SERVICE BULLETIN

MITSUBISHI MOTORS

PURPOSE : CHANGE	ISSUE NO. : MSB-14EXML00-002	DATE : 2014-01-17
SUBJECT : SPLASH SHIELD REMOVAL AND INSTALLATION & OVERFENDER REMOVAL AND INSTALLATION		<DESTINATION/MODEL> (As per attached sheet 1) <M/Y> 13-14
GROUP : GENERAL(Gr:00)		OUTLANDER/OUTLANDER PHEV(GF0W)

Attached sheet 2

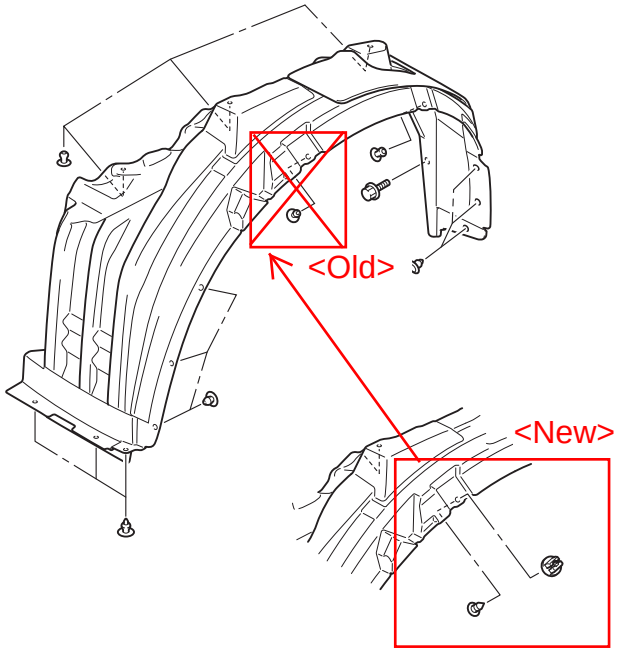
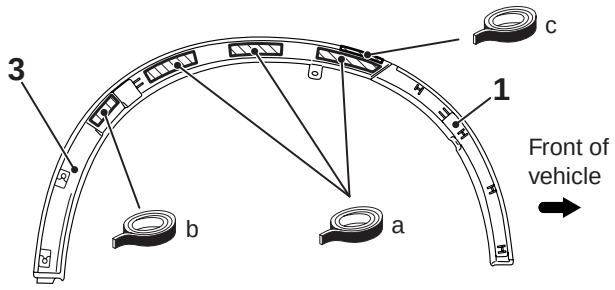
Please refer to the attached document for the information about the change of mention in the applicable service manual. (The grommet screw is used instead of the clip, and the splash shield mounting hole at the fender side is changed from the round hole(diameter:6mm) to the rectangle hole(8.5×8.5mm). Also, the moulding removal of both front and rear bumpers are amended.

As shown above, a grommet screw is used instead of the clip, and the splash shield mounting hole at the fender side is a rectangle hole (8.5×8.5 mm) in place of the round hole (diameter: 6 mm).

<<A>> FRONT BUMPER MOULDING REMOVAL

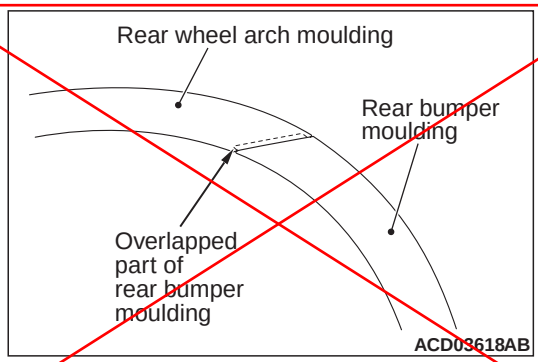
Note that the front wheel arch moulding and the front bumper moulding overlap.

As the front wheel arch moulding and the front bumper moulding overlap, hold the front wheel arch moulding with hand when removing the front bumper moulding to prevent deformation.

<<B>> REAR BUMPER MOULDING REMOVAL

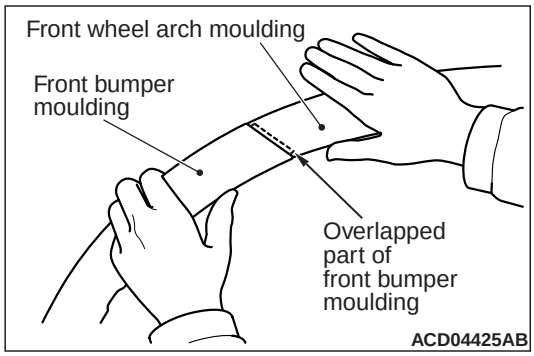
Note that the rear wheel arch moulding and the rear bumper moulding overlap.

As the rear wheel arch moulding and the rear bumper moulding overlap, hold the rear wheel arch moulding with hand when removing the rear bumper moulding to prevent deformation.
